RE: 447 Warburton Ave

Please see attached revised drawings for the above reference address. The changes include the following:

PROPOSED ALTERATION/ ADDITION

AT: 447 WARBURTON AVE. HASTINGS-ON-HUDSON, NY

T-1

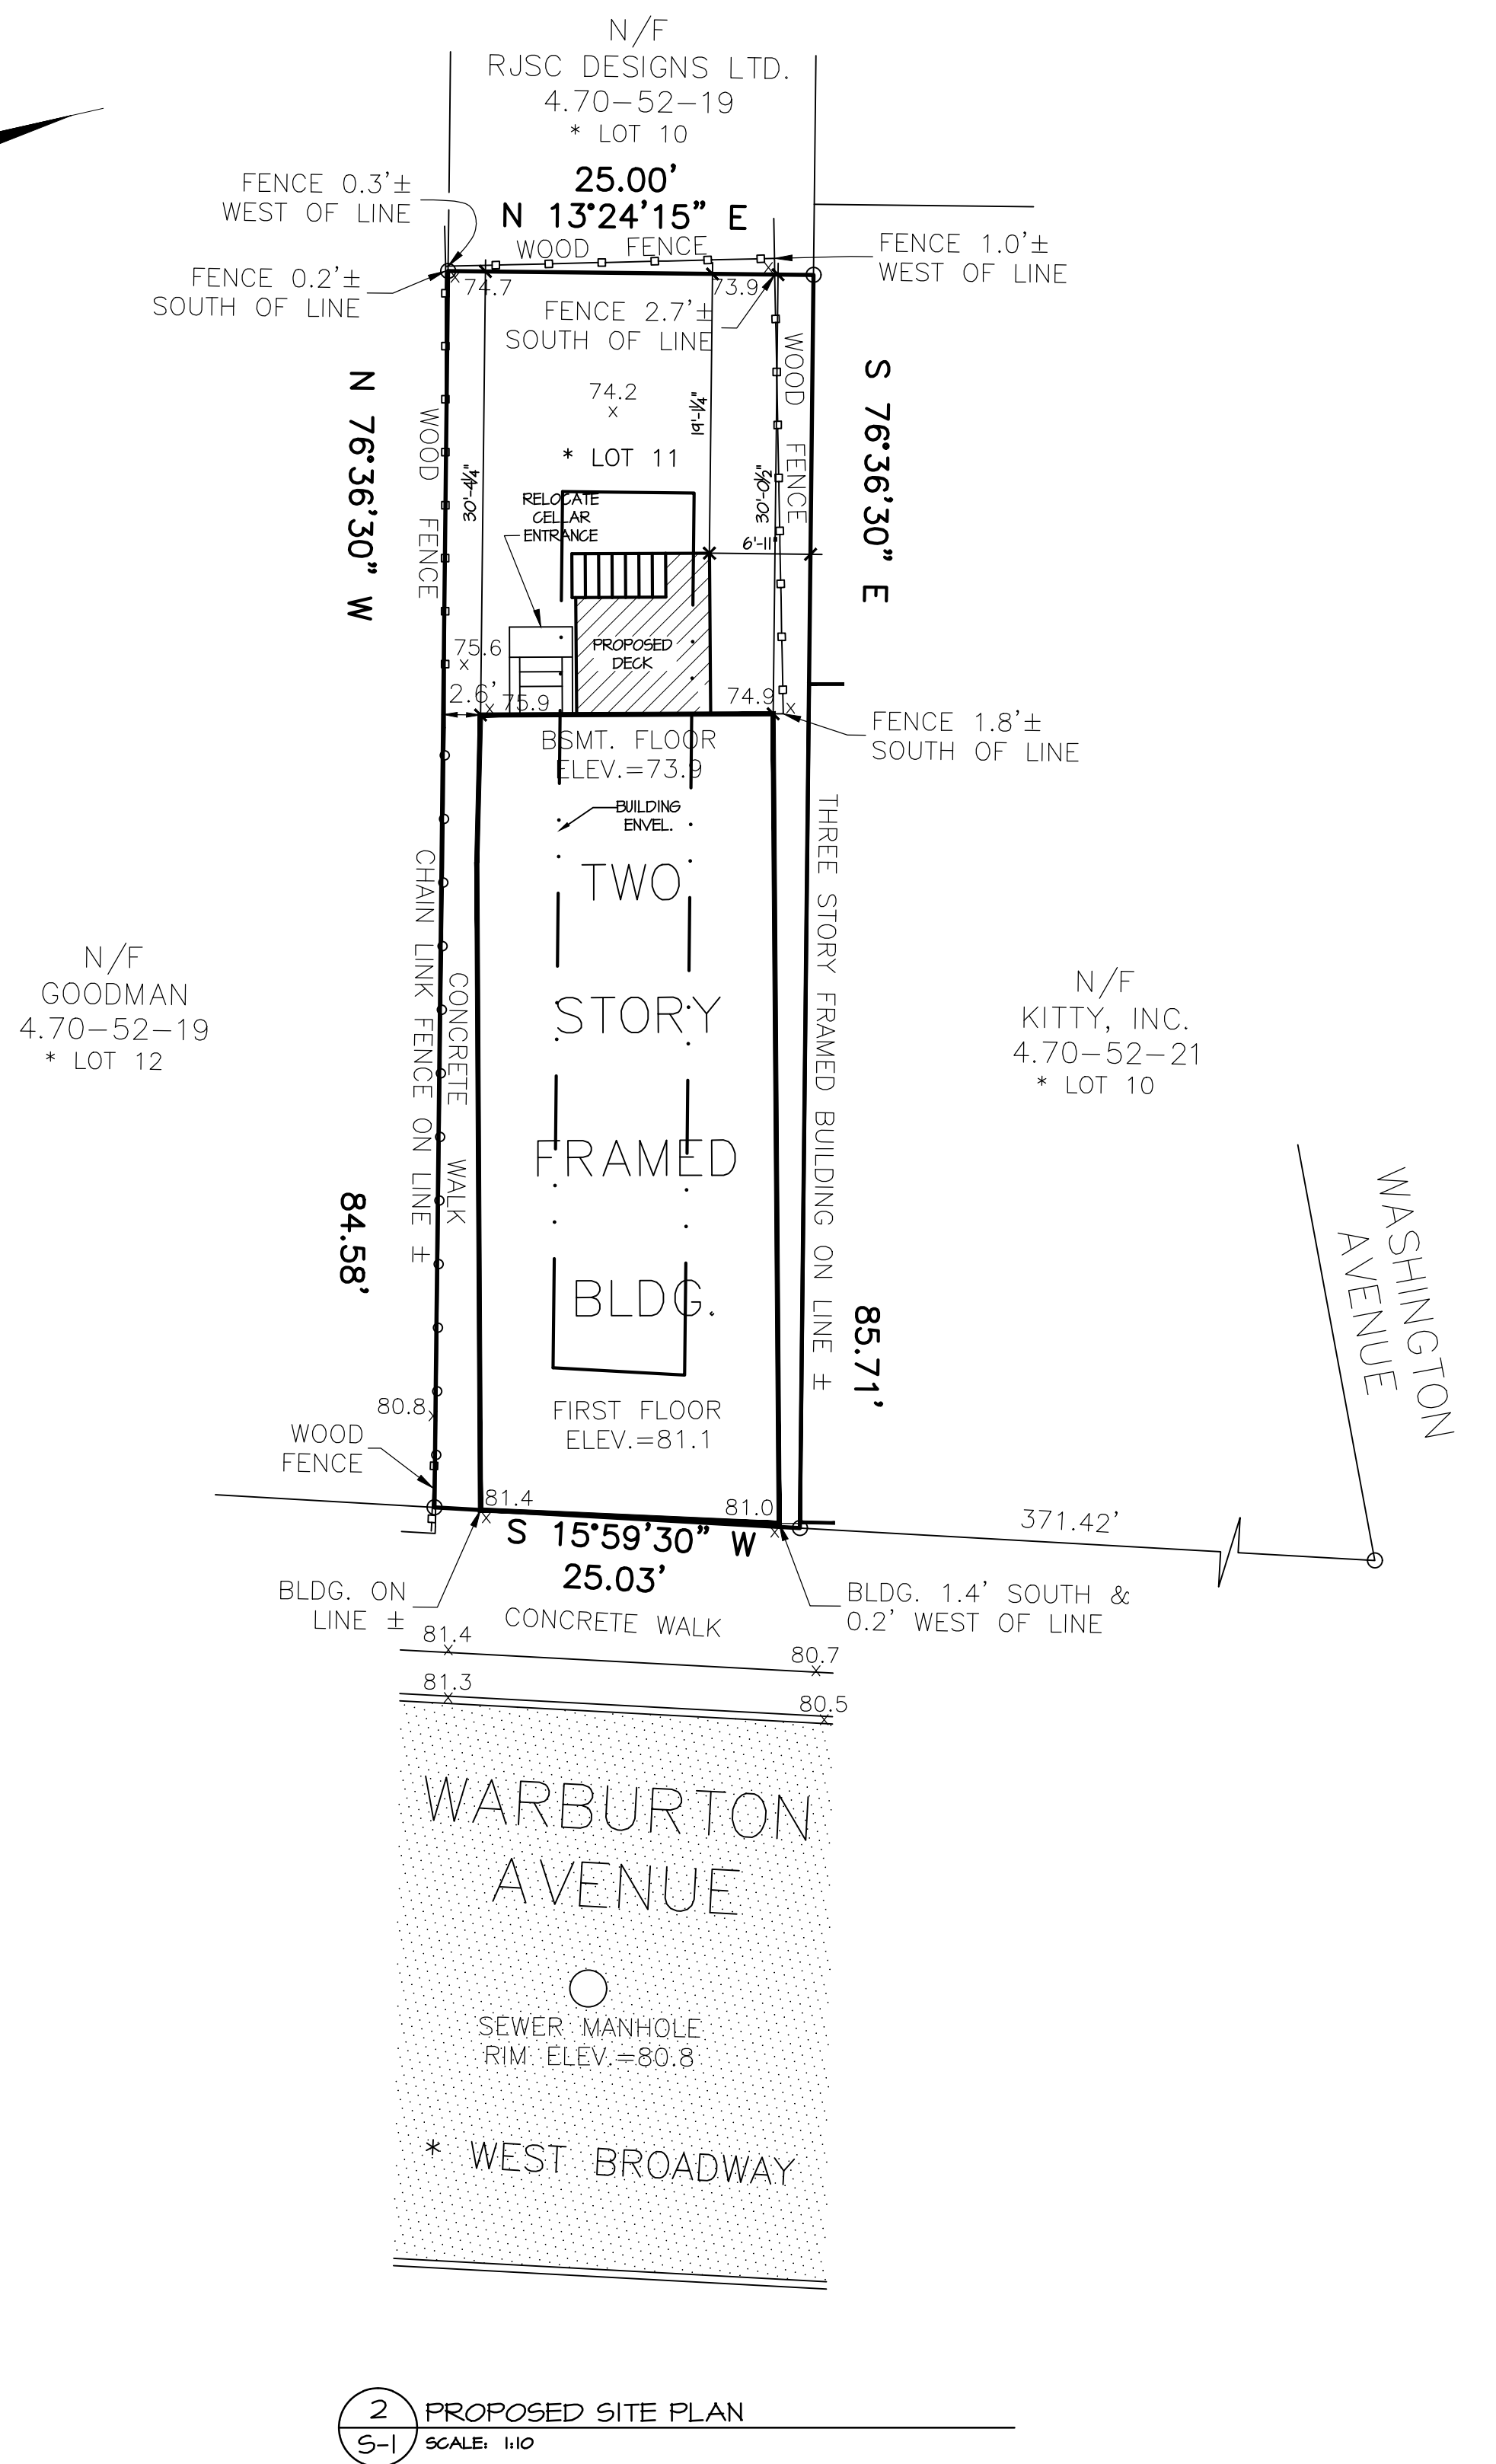
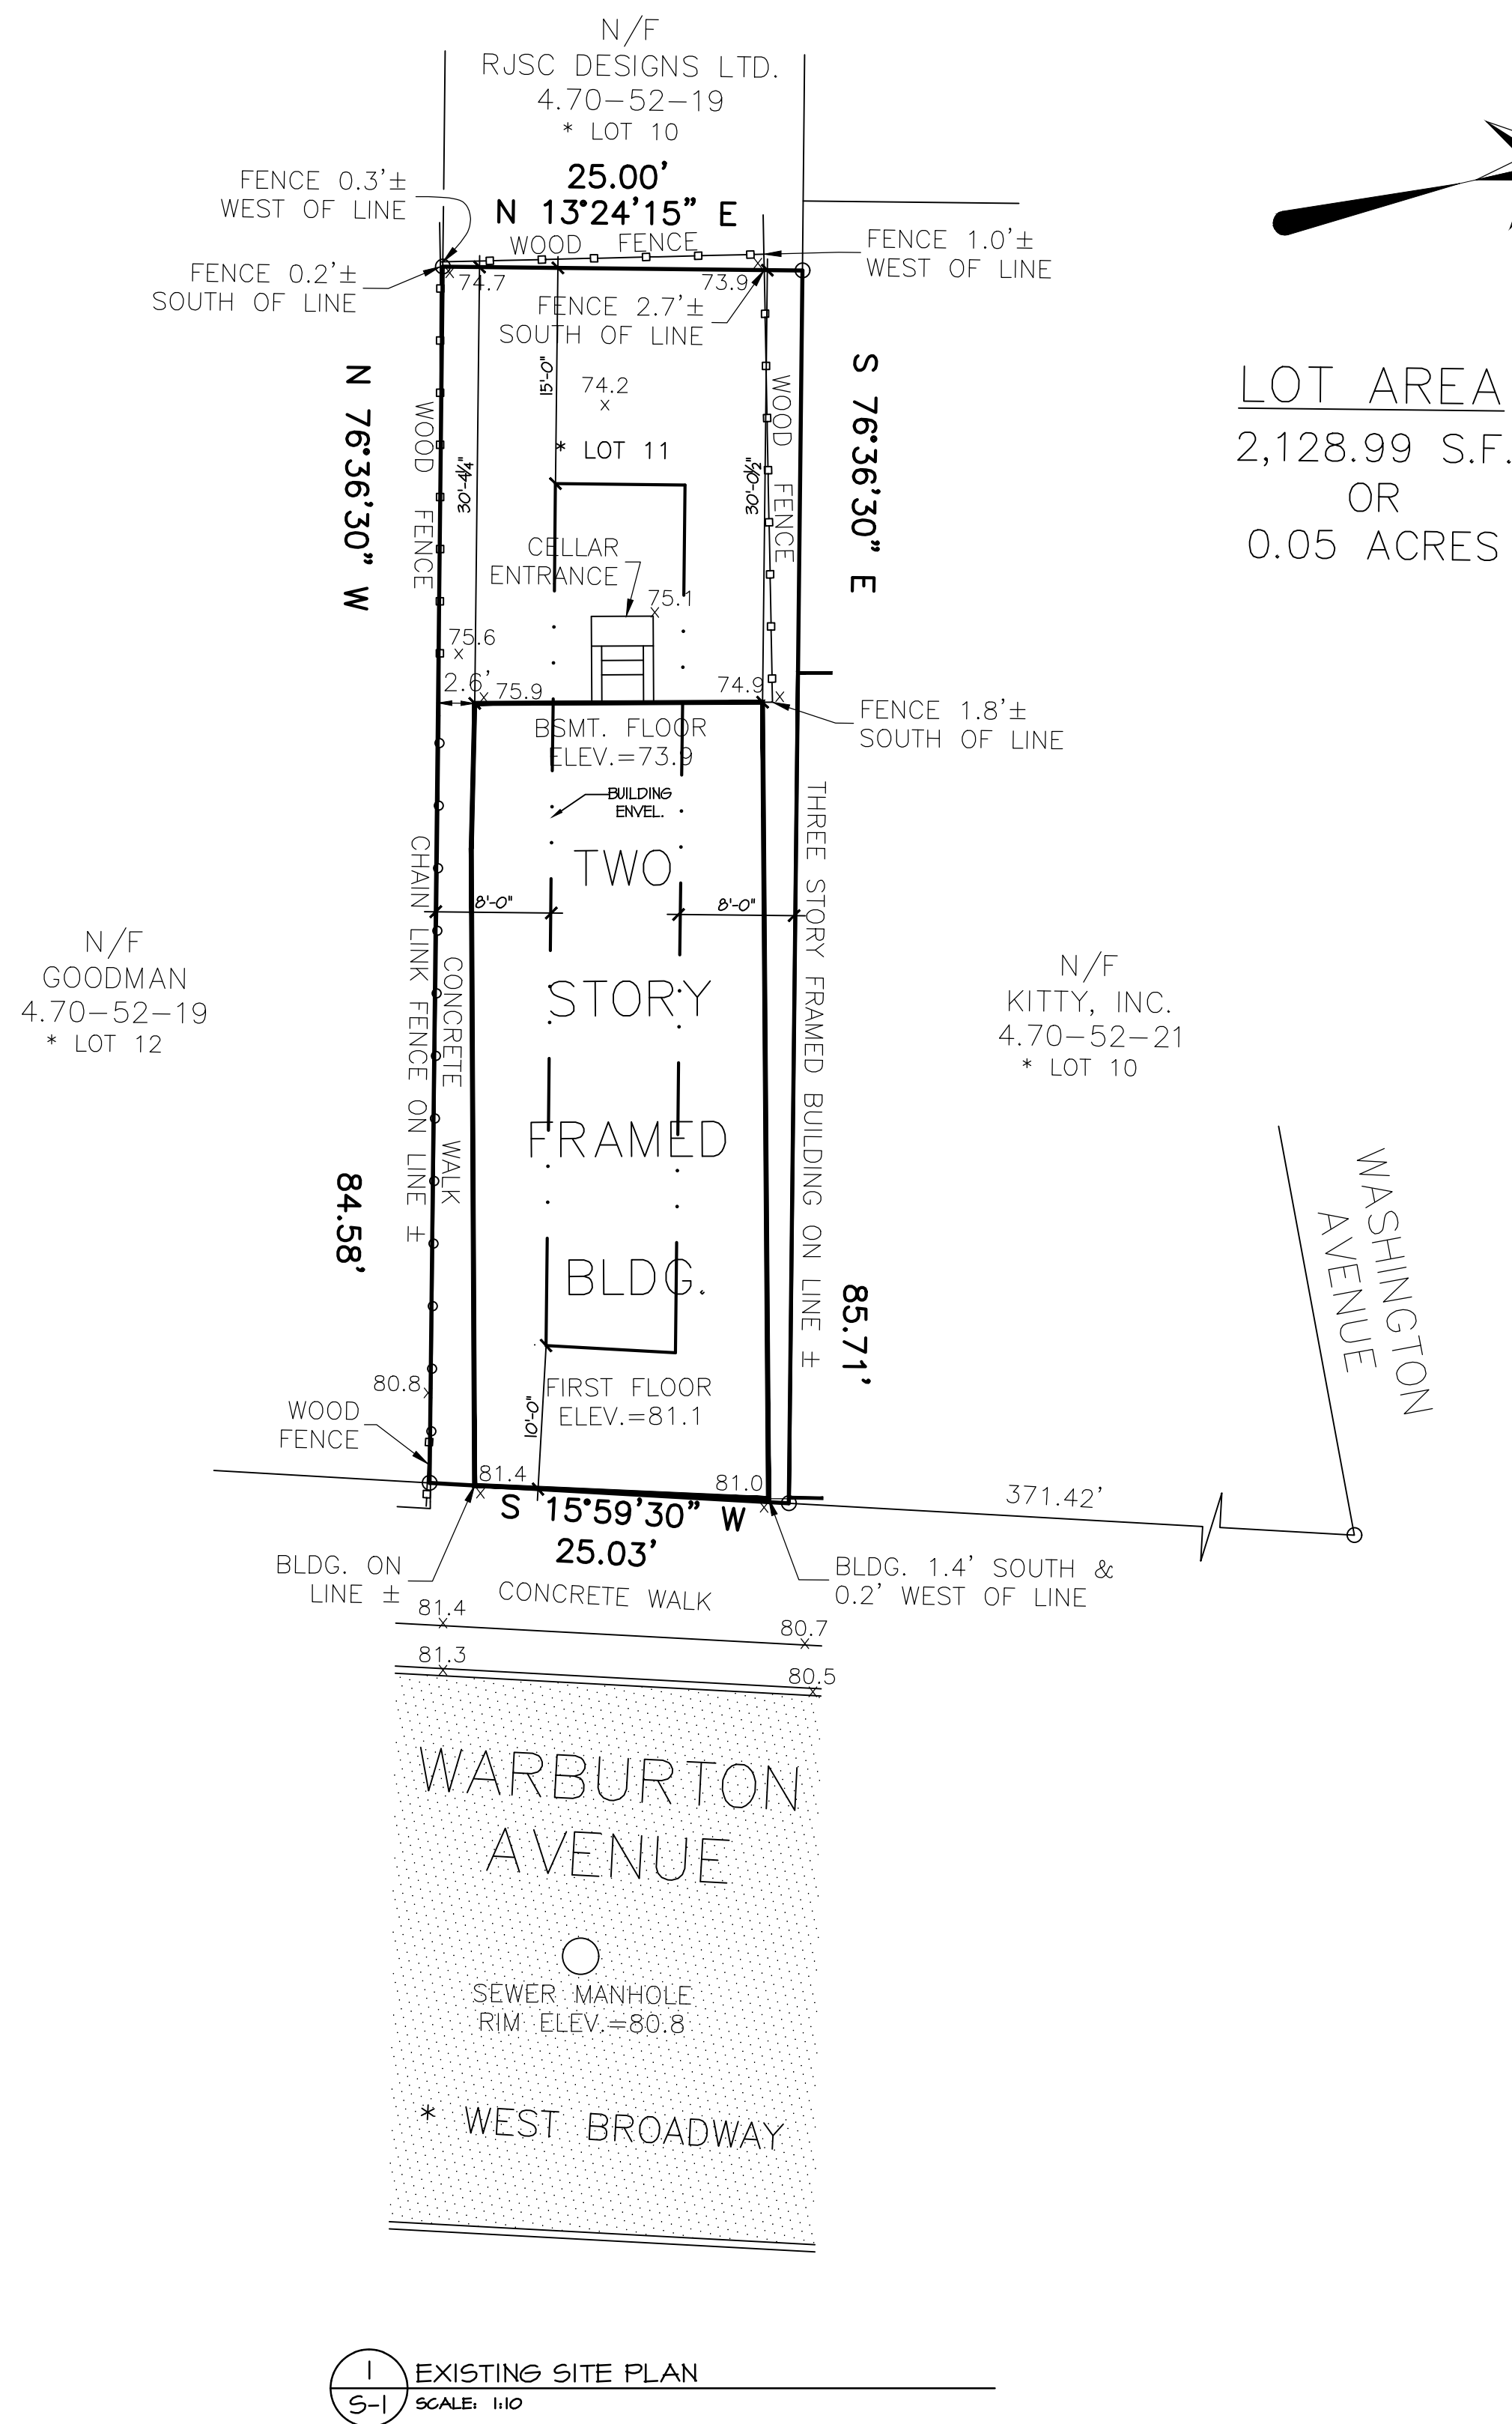
- 1.) The zoning chart has been revised because the deck now complies with the setback
- 2.) We have changed the size of the sliding doors at the rear of the dwelling on the first, second and third floor.
- 3.) The second-floor deck has been reduced and screen walls have been added.
- 4.) The third-floor front wall 4' back from the front setback.
- 5.) Third-floor knee wall has been reduced from 3'-0" to 1'-6"
- 6.) All elevations have been revised
- 7.) Dimensions have been added to ZA-5 sheet.
- 8.) Renderings have been revised and additional angles have been provided.
- 9.) Renderings from neighbor's residence have been added.
